# HIGHLAND PLANNING COMMISSION AGENDA

# PLANNING COMMISSION AGENDA REPORT ITEM #3a

**DATE:** August 26, 2025  
**TO:** Planning Commission  
**FROM:** Rob Patterson, City Attorney/Planning & Zoning Administrator  
**SUBJECT:** Highland Town Plaza Lot 3 Site Plan and Architecture Review  
**TYPE:** Land Use (Administrative)

1. Highland Town Plaza - Lot 3 - Review Comments - 2025.08.21 (Stipulation)
2. Project Narrative
3. 1. Highland Town Plaza Lot 3\_Site Plan
4. 2. Highland Town Plaza Lot 3\_Landscape
5. 3. Highland Town Plaza Lot 3\_Building Elevations and Details
6. 4. Highland Mo'Bettahs TGS 20250328 Signed

SHEET  
**104**

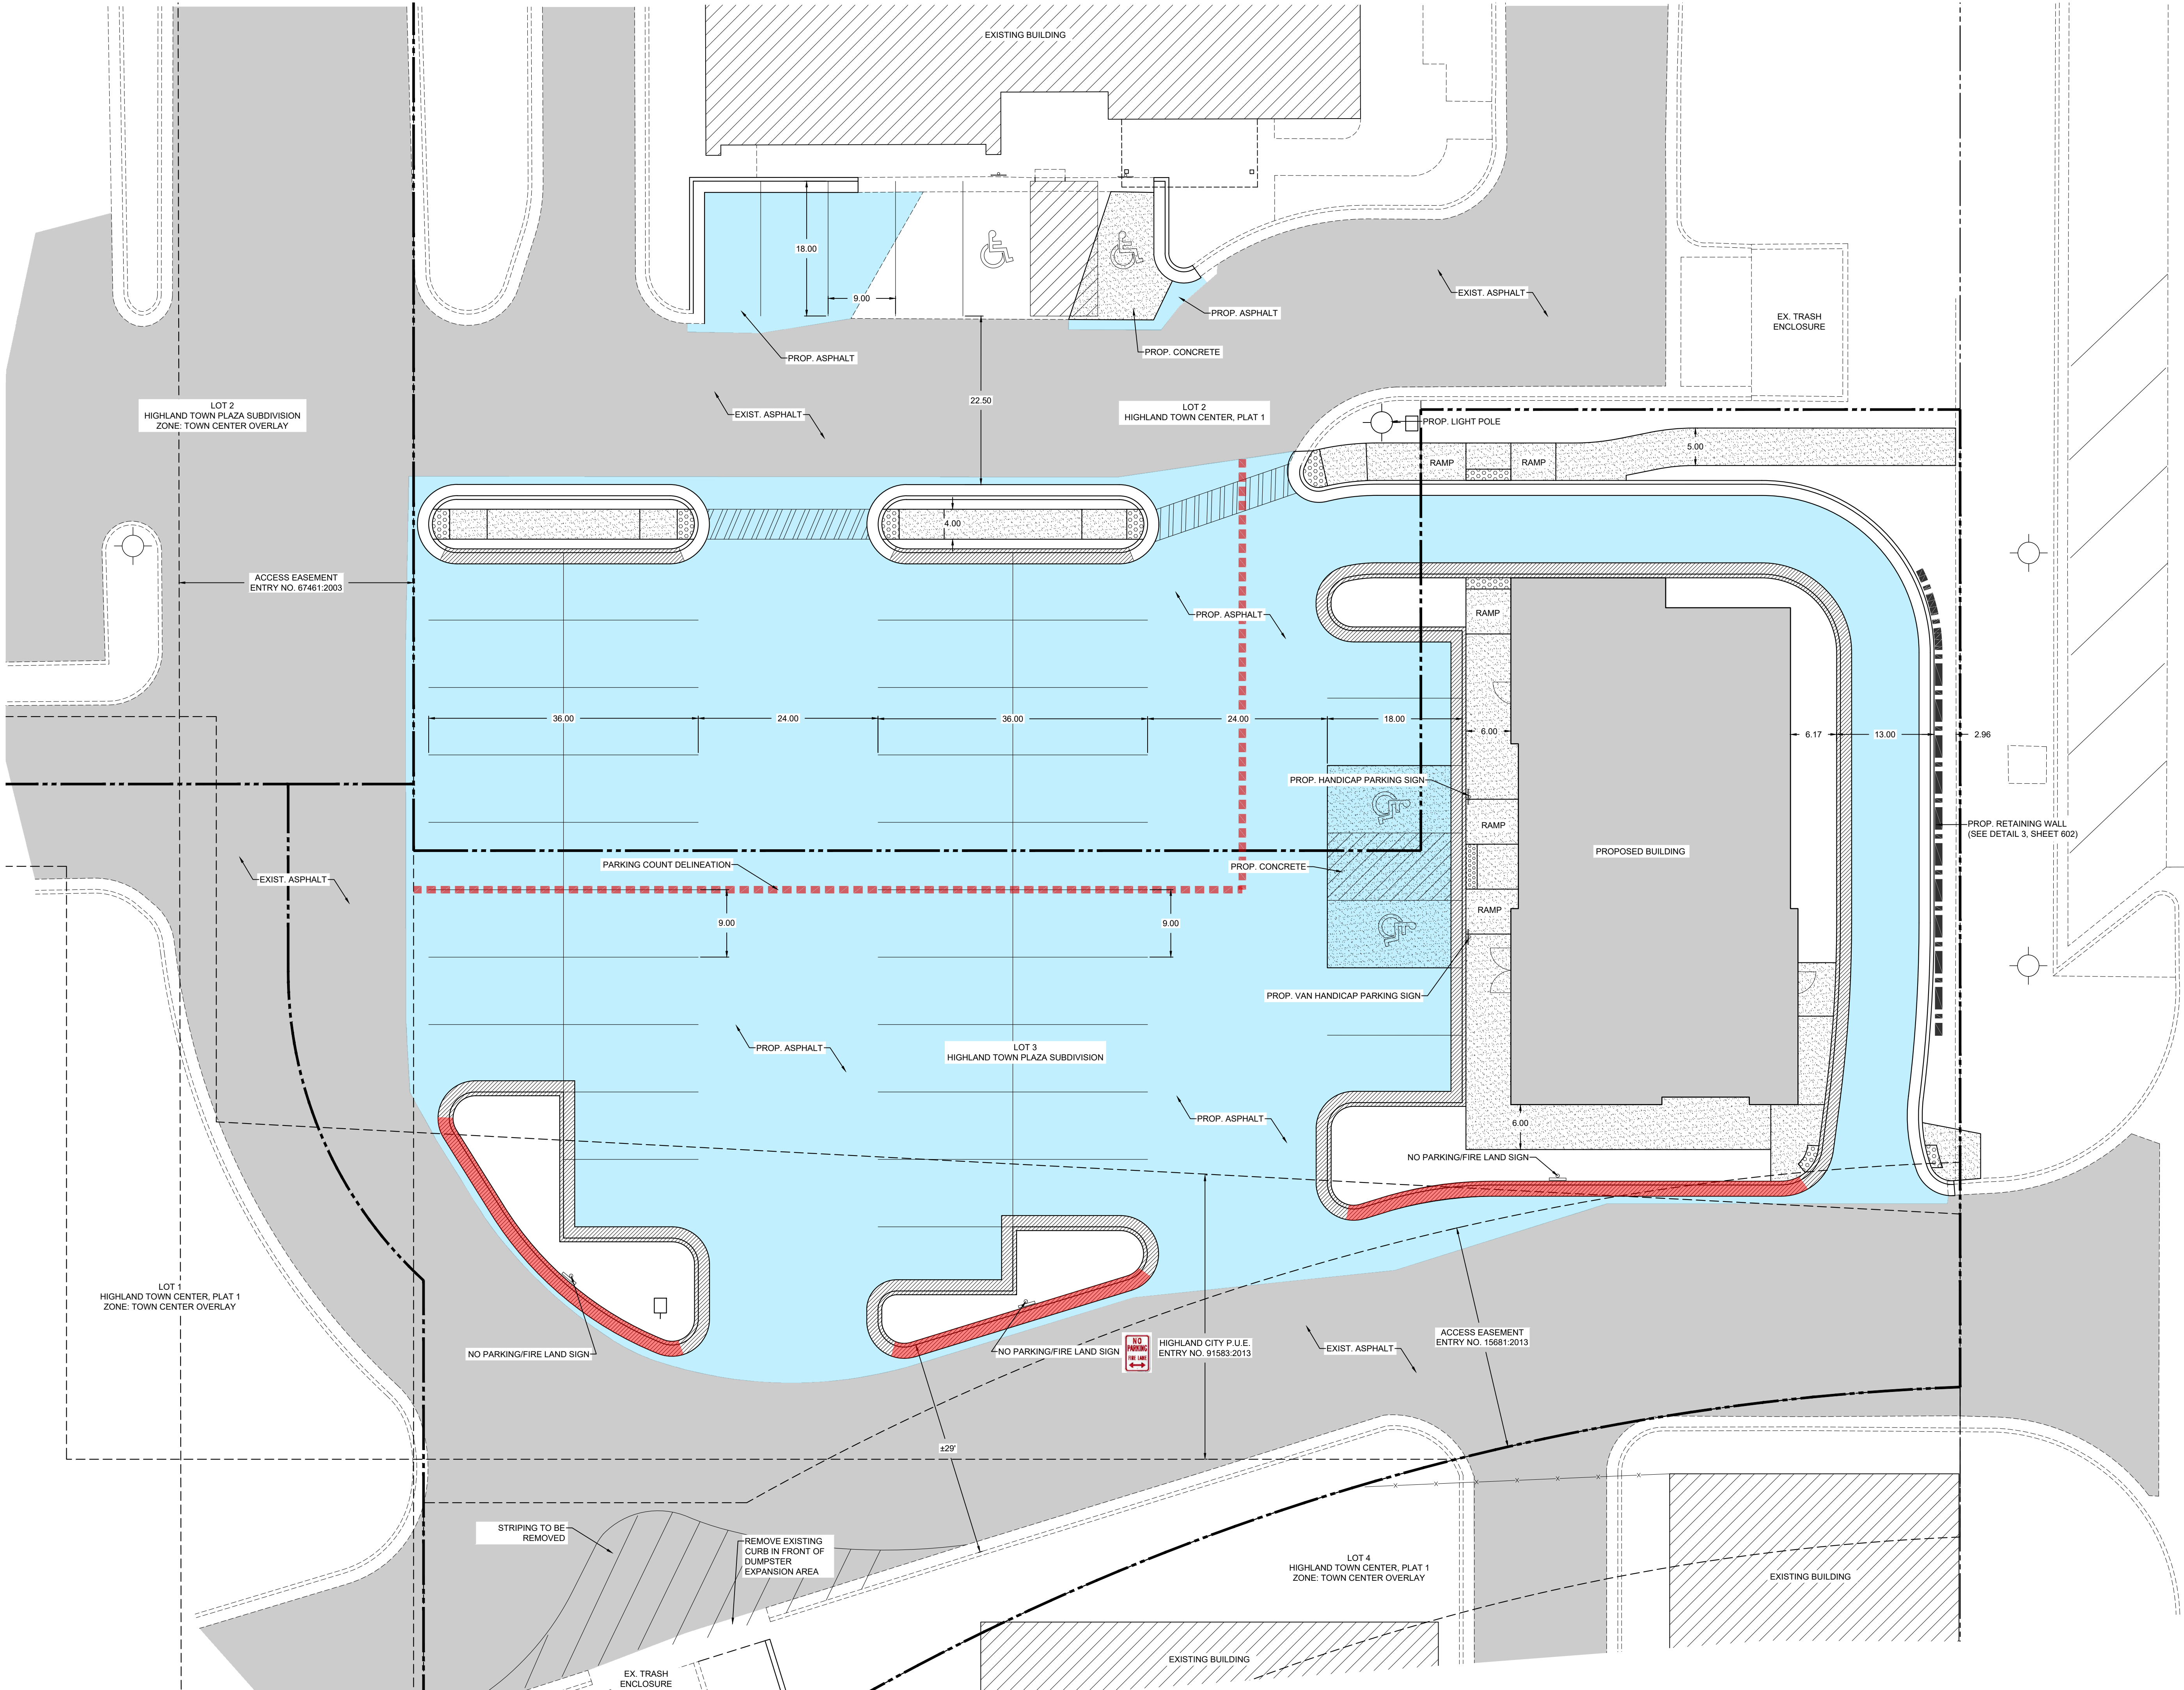
#### **Sheet 104 (Proposed Site Plan):**

5. Provide a clear description of trash enclosure changes.
  - a. The details for the trash enclosure conflict between the plan sets.  
Please make corrections and resubmit.
6. South access road (south of lot 3) must remain clear at all times for fire department access. Provide signing, striping and red-painted curb to communicate this requirement to the public. No queuing allowed due to the pickup line.
  - a. This item will remain as a reminder.

7. All easements must be clearly identified on the site plan. Please include all utility easements.
  - a. Please show and label all access and utility easements, as well as Highland City right of way on sheets 201 and 301.

SHEET  
301

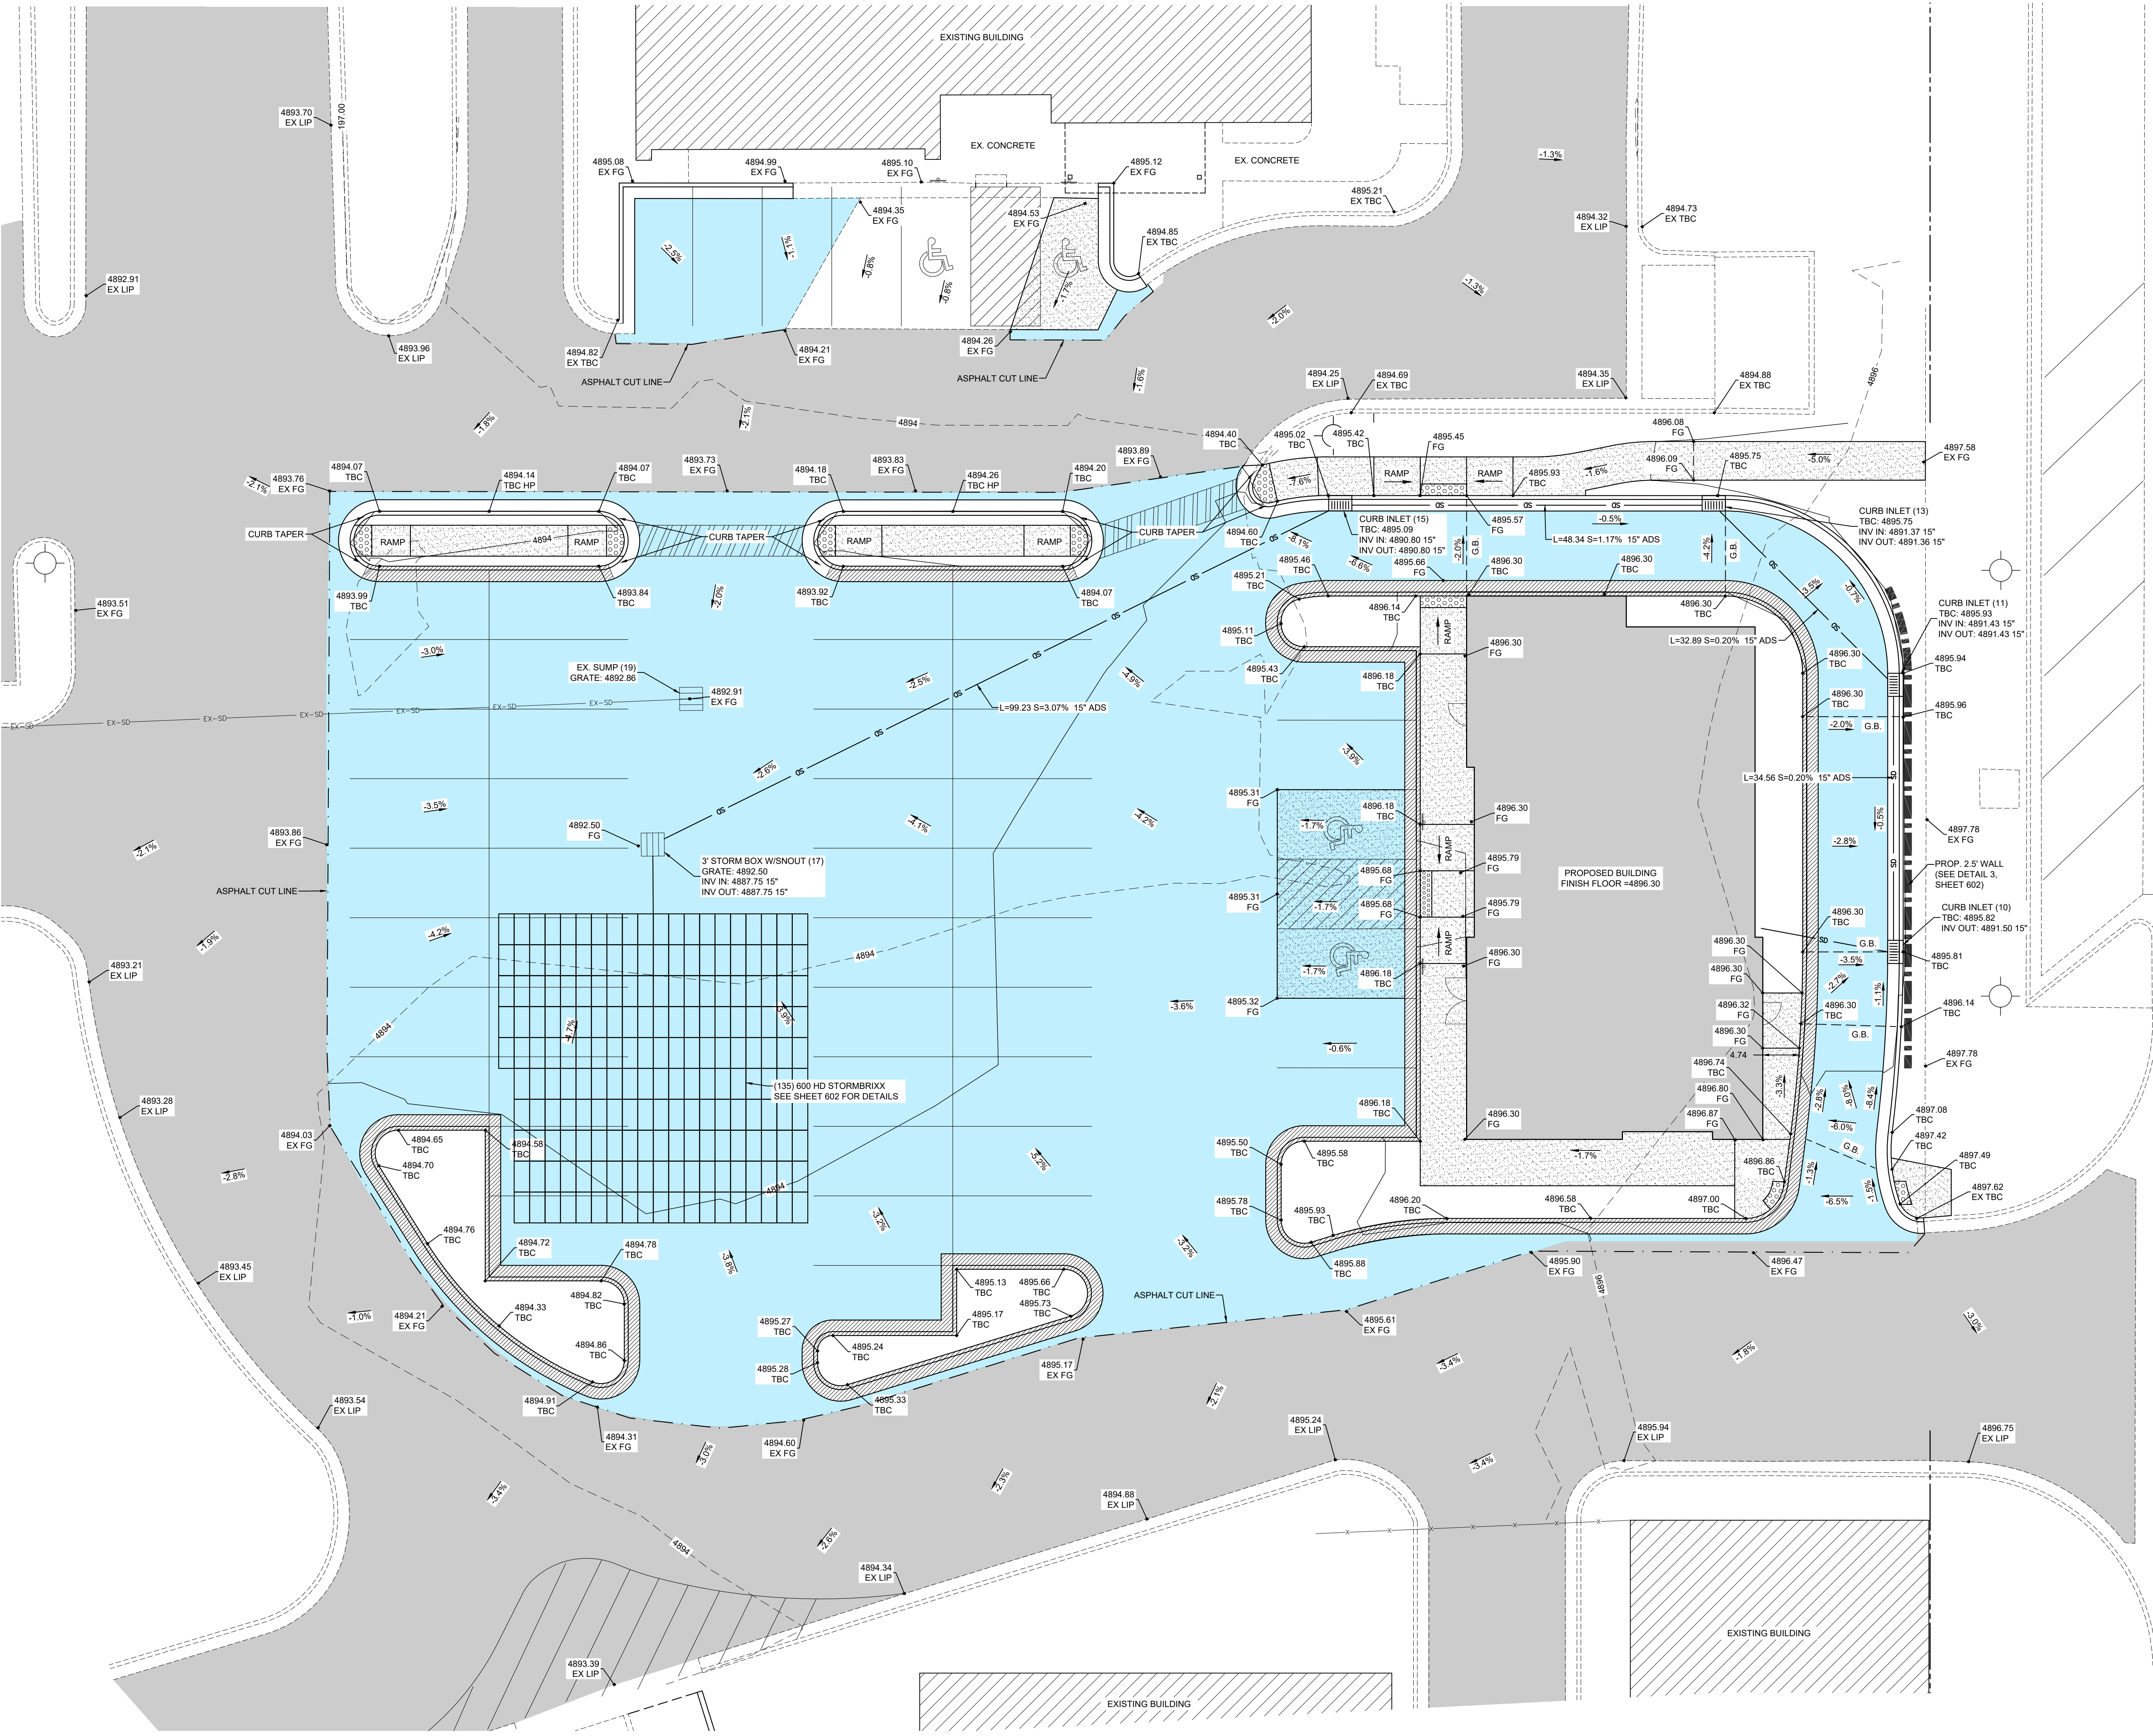
**Sheet 301 (Grading Plan):**

12. Provide details for the proposed retaining wall.
  - a. Provide more detailed information showing how the proposed curb inlets will be built with the proposed retaining wall footing as shown.

- b. Provide more detailed information showing where the gas line will be located in relation to the retaining wall and 4" perforated pipe and how it will be protected in place.
  - c. Show the utility easement for the gas line as per previous comments.
- 13. Provide updated storm drain system calculations based on the infiltration safety factor.
  - a. Please provide the specific cover and construction details for the installation of this storm drain system in addition to the general detail provided.
  - b. Label all inverts on the Stormbrixx Profile View.
- 14. Provide pavement cross section for proposed asphalt.
  - a. Concrete cross section does not match the geotechnical report. Please confirm all pavement and concrete cross sections.
